Detailed Site Plan Departure from Sign Design Standards Wawa Old Branch Avenue

DSP-19056
DSDS-710

SUBJECT: Detailed Site Plan DSP-19056
 Type 2 Tree Conservation Plan TCP2-041-2020
 Departure from Sign Design Standards DSDS-710
 Wawa Old Branch Avenue

Site Plan

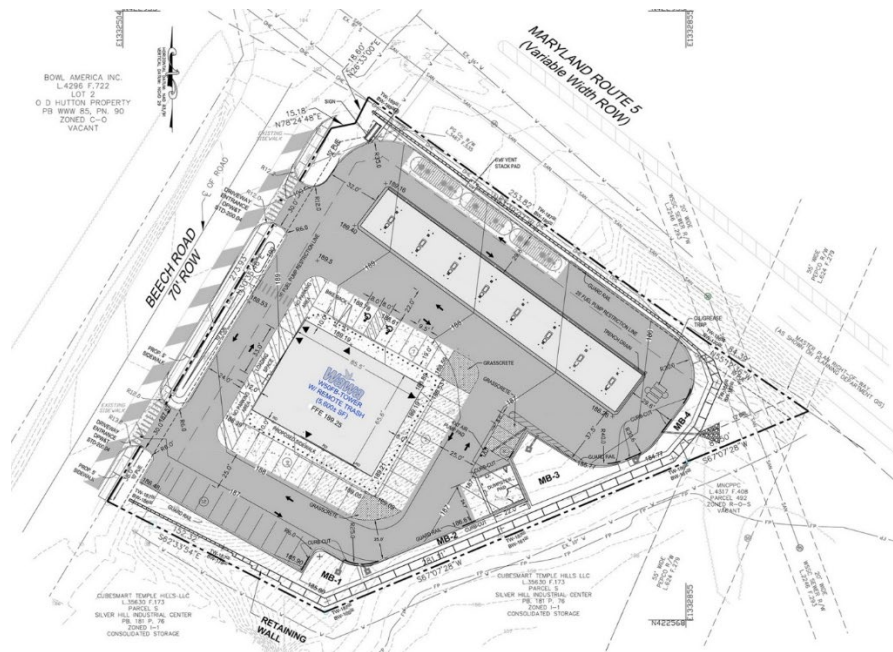
The loading space is located along the northwest side of the building and faces Beech Road. There was discussion regarding relocating the space to the southeast site of the building, but the applicant was unable to satisfy the request due to feasibility and other site restrictions. The applicant is proposing to install a berm and heavy landscaping within the island located along the right-of-way, in conformance with Section 4.4(c)(2) of the 2010 *Prince George's County Landscape Manual* (Landscape Manual) to address the concern of the visibility of the loading space.

1. Prior to certification, the detailed site plan shall be revised as follows:
 - a. Label the height and dimensions for the food and beverage store and gas station canopy.

- b. Revise the parking calculations to include the number of employee spaces and the breakdown of the parking spaces by use.
 - c. Provide the dimensions of the parking spaces on the plan, with one in each bay.

- d. Label the building setback and the freestanding sign setback from the street line to demonstrate conformance with Section 27-614(a)(1) and (a)(4) of the Prince George's County Zoning Ordinance.

Architectural Elevations

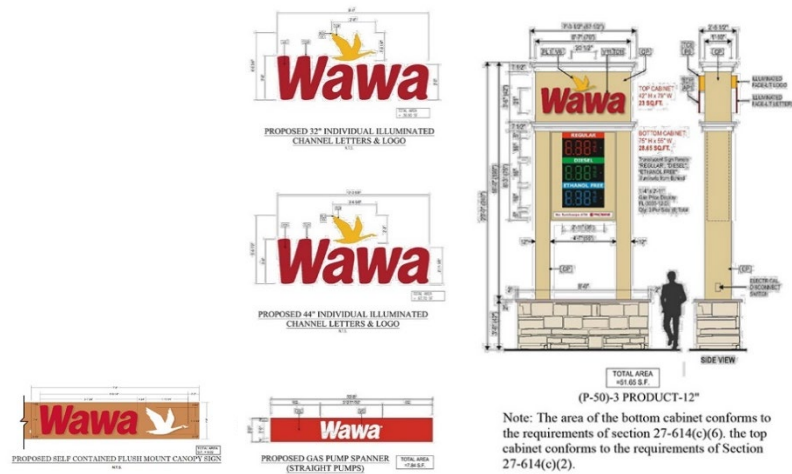
The proposed 5,600-square-foot Wawa food and beverage store is a single-story structure in the middle of the site and oriented towards MD 5. The front of the building facing MD 5 and side facing Beech Road will include multiple windows and roof features. The gas station canopy will have a slanted roof with a maximum height of approximately 21 feet with signage. The façade of the building will contain a combination of exterior insulation finishing system dryvit and manufactured stone veneer. Both the building and gas station canopy will have aluminum dutch seam roofing.
